SITE PLAN REVIEW AND APPEARANCE BOARD STAFF REPORT

1625 South Ocean Boulevard

Meeting	File No.	Application Type
January 25, 2023	2023-031-SPF-SPR-CL1	Class I Site Plan Modification
Property Owner	Applicant	Agent
1625 South Ocean, LLC	1625 South Ocean, LLC	Thomas F. Carney, Carney Stanton P.L.

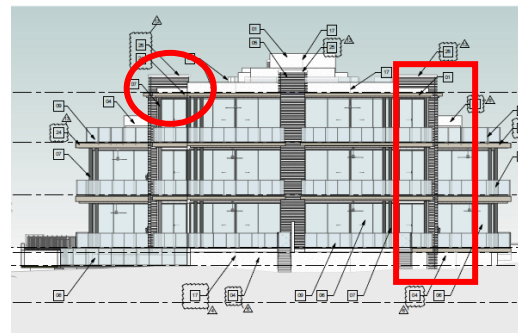
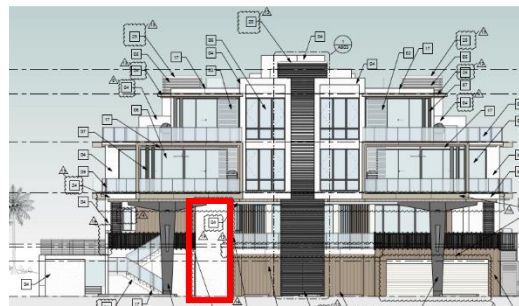
- Minor changes to the architectural details such as the removal of two windows from the front elevation due to elevator constraints and slight changes to the windows in Unit eight (lower transom windows eliminated due to a request by the owner), cladding added to the right side to be consistent with the other vertical columns, and roof screen adjustments.
